# Access Compliance Report

## Public Rights-of-Way

Intersection ID: 21797	Main Street: GALLERIA_BV	Cross Street: MONROE_RD	Location: NE
ADA ID: 3234B6394CC1	Ramp Type: Perp	Initial Pass/Fail: Fail	Overall Compliance: No
			Severity Score: 48.75
Codes/Mitigation Info/Possible Solution		Field Measurements/Component Compliance

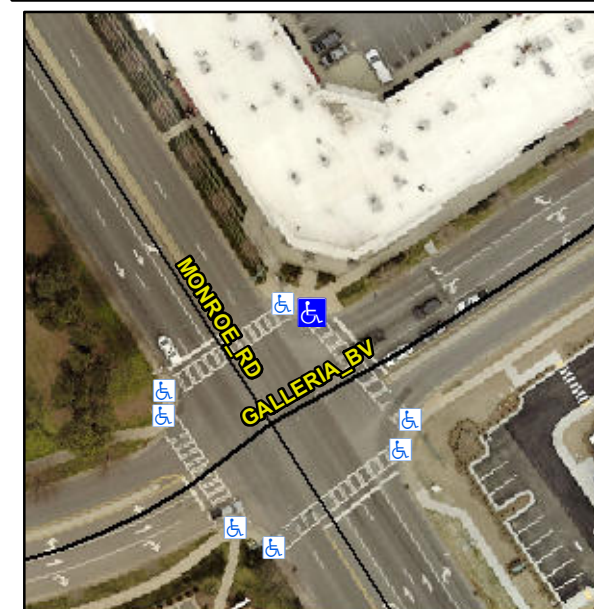
**R304.5.1, R304.2.2, R304.5.3**

Compliance	Description	Data	Compliance	Description	Data
N/A	Ramp Length (in)	170.0	No	Ramp Slope (%)	8.5
No	Ramp Width (in)	25.0	No	Ramp XSlope (%)	2.2
N/A	Flare Type LT	N/A	N/A	Flare Type RT	N/A
N/A	Flare Slope LT (%)	N/A	N/A	Flare Slope RT (%)	N/A
N/A	Flare Traversable LT?	N/A	N/A	Flare Traversable RT?	N/A
N/A	Landing Length (in)	N/A	N/A	DWS Provided?	N/A
N/A	Landing Width (in)	N/A	N/A	DWS Contrast?	N/A
N/A	Landing Slope (%)	N/A	N/A	DWS Length (in)	N/A
N/A	Landing X Slope (%)	N/A	N/A	DWS Full Width?	N/A
N/A	Landing Curb? (Y/N)	N/A	N/A	DWS Offset (in)	N/A
N/A	Shared Landing?	N/A			
N/A	Gutter Ponding?	N/A	N/A	Gutter Slope (%)	N/A
N/A	Gutter Lip Ht (in)	N/A	N/A	Gutter X Slope (%)	N/A
N/A	Painted X Walk1?	Yes	N/A	Painted X Walk2?	N/A
	X Walk 1 Direction	To SE		X Walk 2 Direction	N/A
N/A	X Walk 1 Width (in)	103.0	N/A	X Walk 2 Width (in)	N/A
	X Walk 1 Slope (%)	2.4		X Walk 2 Slope (%)	N/A
	X Walk 1 X Slope (%)	1.3		X Walk 2 X Slope (%)	N/A

**Remove & Replace Entire Ramp.**
